# GEOMORPHIC CHANGES IN LOWER CACHE CREEK 2012

## *Technical Memorandum*

Cache Creek Technical Advisory Committee  
Natural Resources Program  
Yolo County Board of Supervisors

Figure 4 Erosion near RM 25.5  
The area in red shows significant erosion between 2010 and 2011.

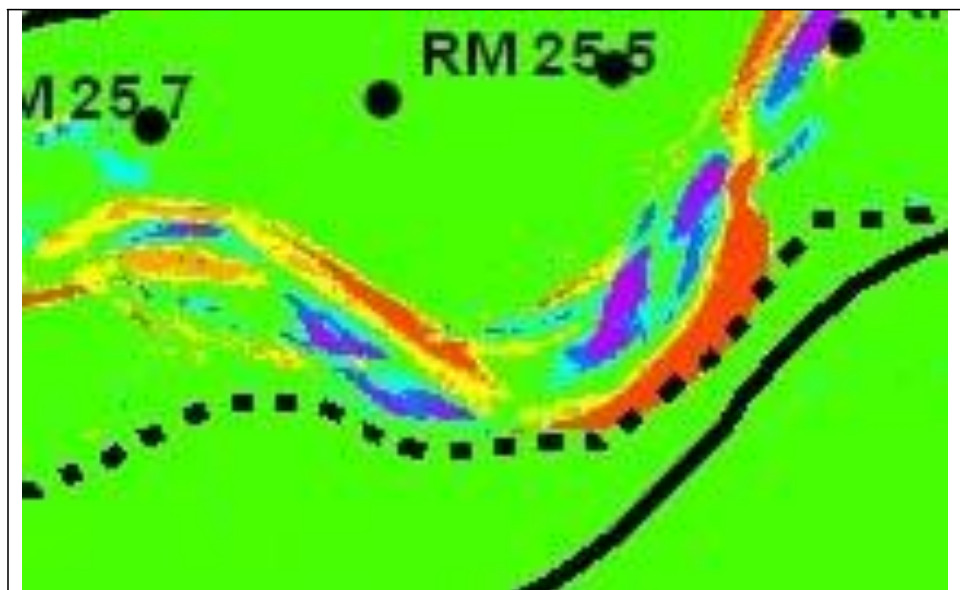
The bank retreat patterns near RM 25.4 -25.5 show that the channel bends in this location are evolving in a typical pattern for stream channel evolution. The 2010-2011 DTM maps show significant erosion in this location (Figure 4). Downstream from this, the bank is pinned in place by cement material that was placed to limit bank retreat. This constraint to the natural movement has probably caused the upstream bend to be curved more than it would be naturally and, in response, to erode more rapidly. One possible management action would be to remove the concrete constraint, and to allow more natural dynamics in this location. The consequences of this to downstream private land would have to be assessed. Removing the concrete might allow too much erosion onto the Jensen property where there is orchard land, and there would be concern about erosion in that direction. This is one area where evaluating the different management options would benefit from defining the location of the “test 3” line.

Another possibility is that the large bend will cut through and make a cut off in the flat area between the two limbs of the meandering course of the low flow channel, and the channel will move away from the bank naturally, with the rock left in place.

**Action:** Determine the location of the “test-3” line in this location.

Figure 5 RM 22.0 bank retreat

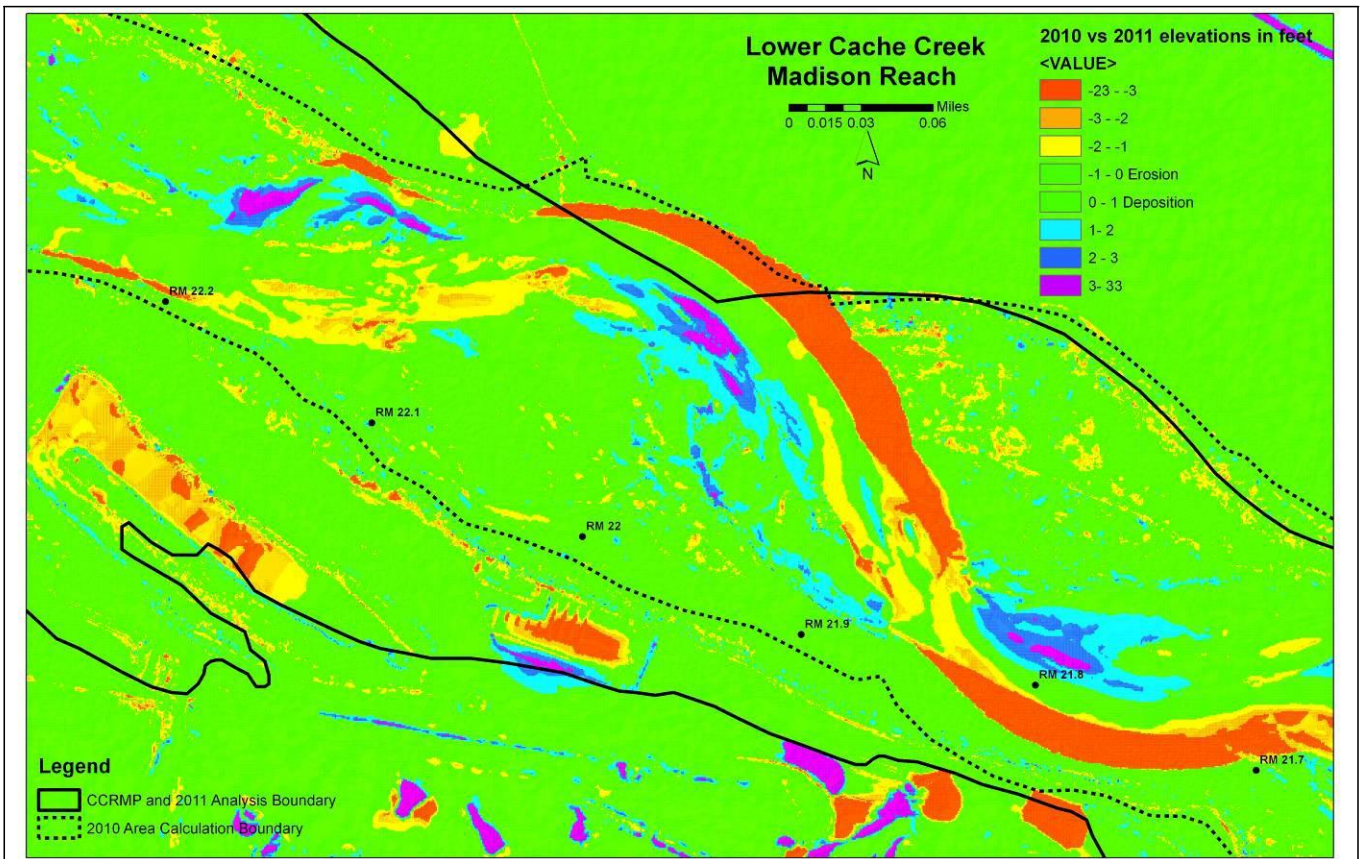
At RM 22.0 there is bank retreat as shown in the cut and fill maps (Figure 5). A former hypothesis was that the meander migration and bank retreat would leave in its wake a created floodplain on which natural regeneration of riparian vegetation could occur. When observing this area in the field, we observed that this is possible only in a long time period, because the adjacent cut bank is almost 20 feet high and, as the locus of erosion tends to move downstream, it will be a relatively long time before the area could develop a floodplain. This is probably not a site that could be relied on for short-term natural regeneration. We should continue to observe the channel processes as they occur at this site. Another important aspect of this site is that it is an area where the bank retreat has taken the current bank of the stream outside the CCRMP boundary. No management action is currently recommended.

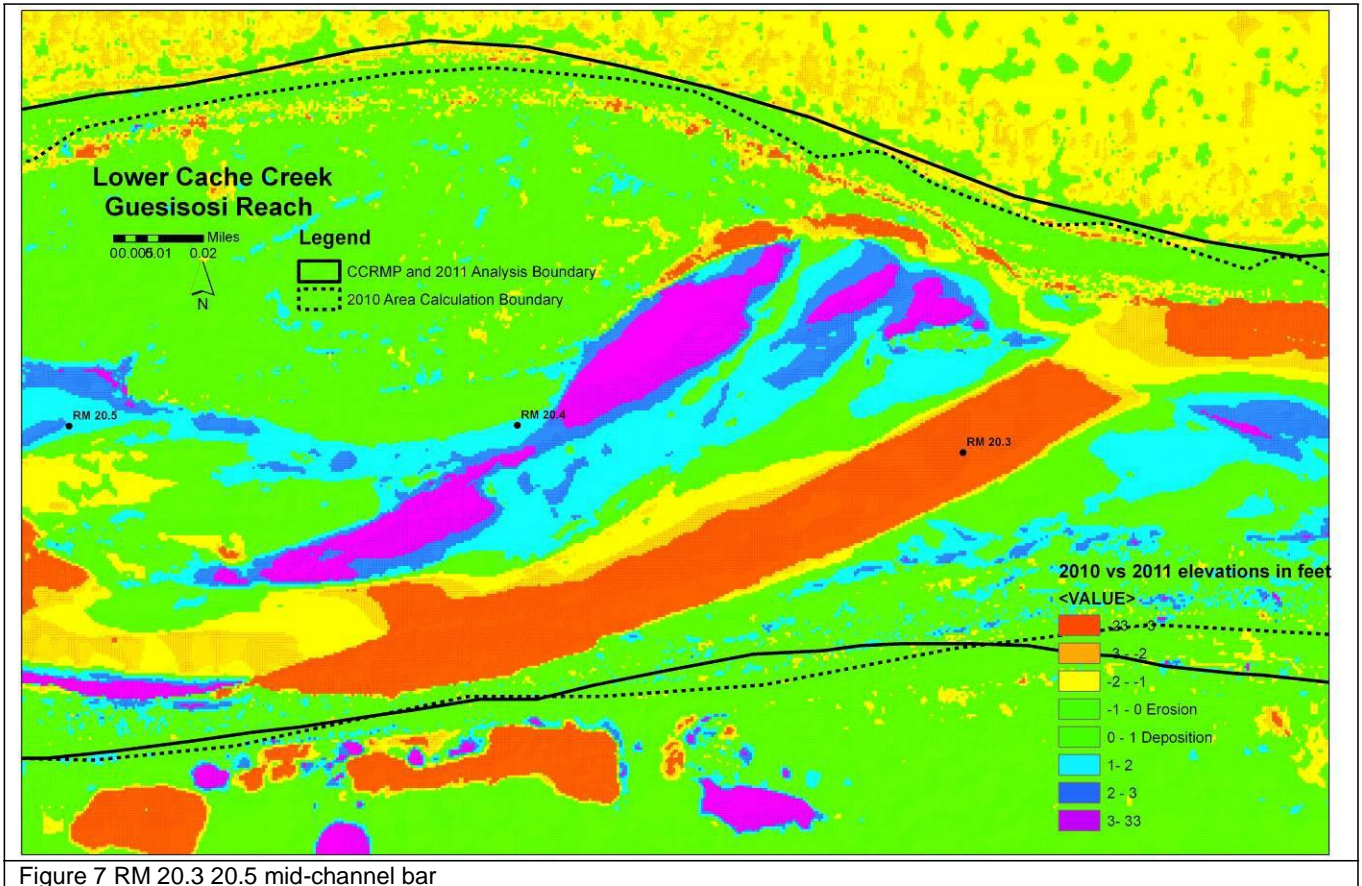
In the vicinity of the most upstream of the CEMEX repair sites (called site F) there is evidence of a mid-channel bar that has deposited, which is shown in purple on the figure (Figure 7). If the bar were removed, there would be less erosive pressure on the south bank. This is a possible location for “bar-skimming.”

**Action:** Discuss this possibility at a future TAC meeting.

Figure 8 RM 18.2-18.0 upstream from the Moore Siphon

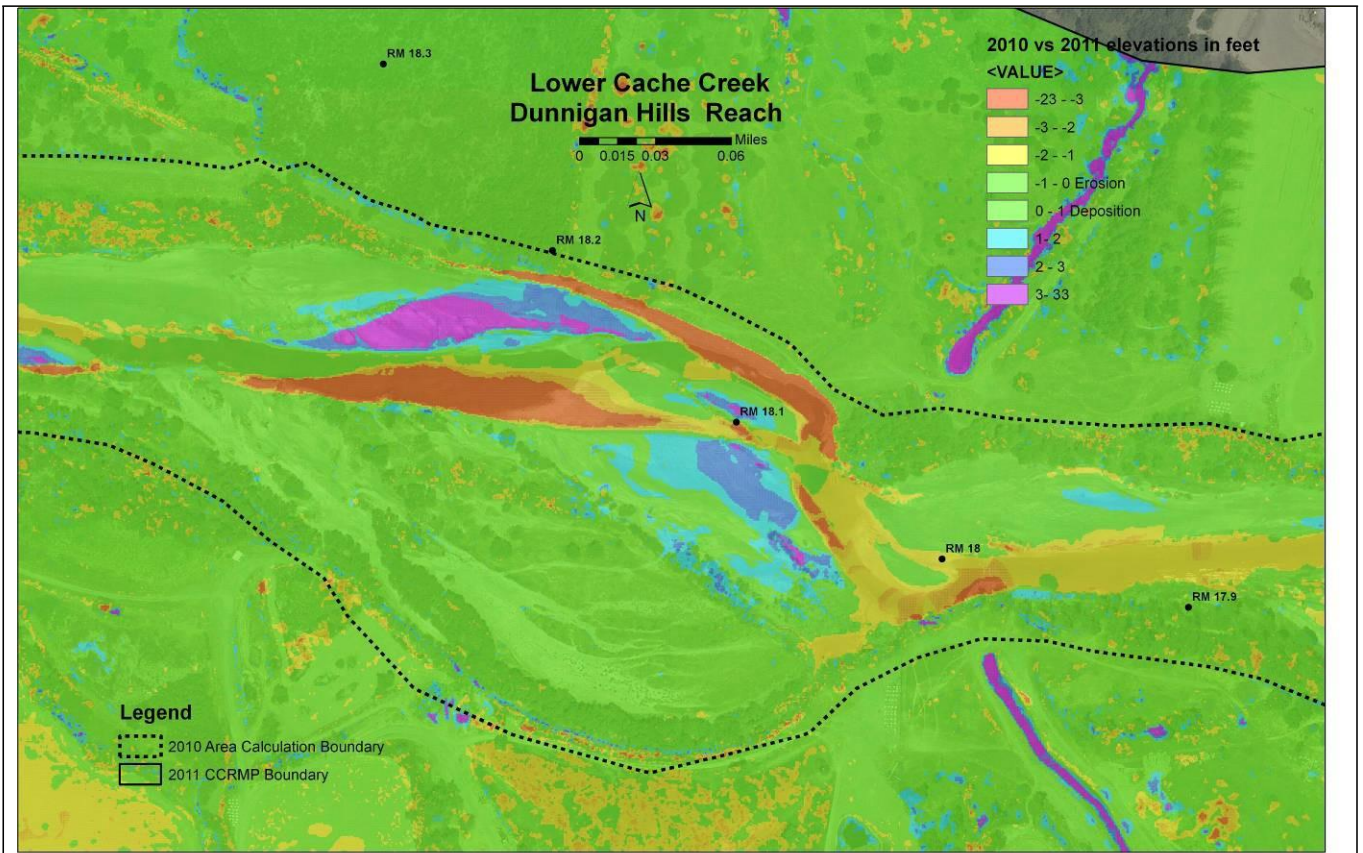
Immediately upstream from the Moore Siphon, there is bank retreat and a large curved scallop in the bank configuration where the downstream cottonwood forest has restrained the migration. The scallop creates a scour hole in the channel that promotes a diversity of in-channel habitats. There are deep-pool habitats. Large wood is falling into the scour hole (pool), which also contributes to in-channel habitat diversity. WE understand that the local landowner is in favor of allowing this process of bank erosion to occur as a natural process.

**Action:** Observe the natural processes as they occur, and document the benefits that we currently see and that we expect to see in the future.

Figure 13 Channel bed erosion at Esparto Bridge

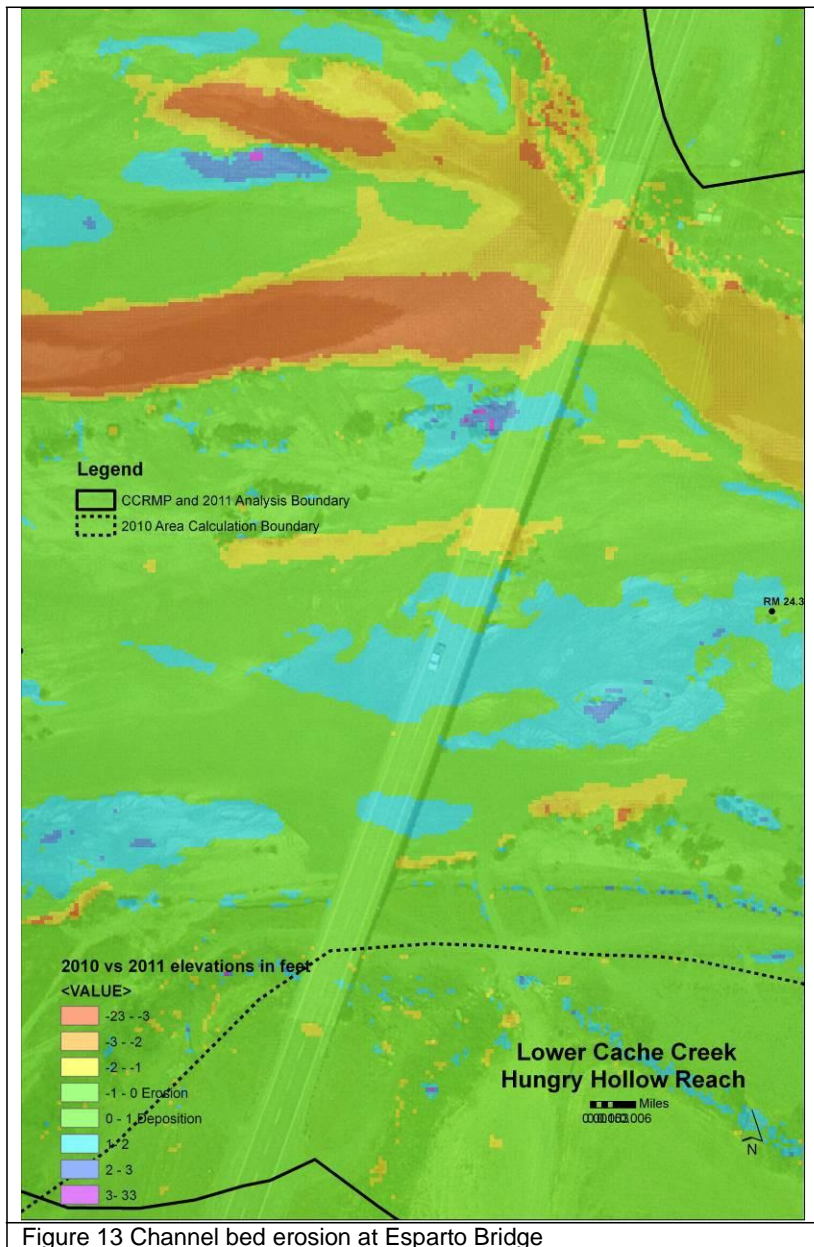
The 2010-2011 DTM analyses (Figure 13) and the cross section plots which were analyzed (not shown here) show some erosion on the north side on the upstream cross sections. This erosion was also observed on the northern-most pier (Figure 14).

It is possible that the erosion on the northern side of the bridge will continue. Observations should be continued, but no action is recommended at this time.
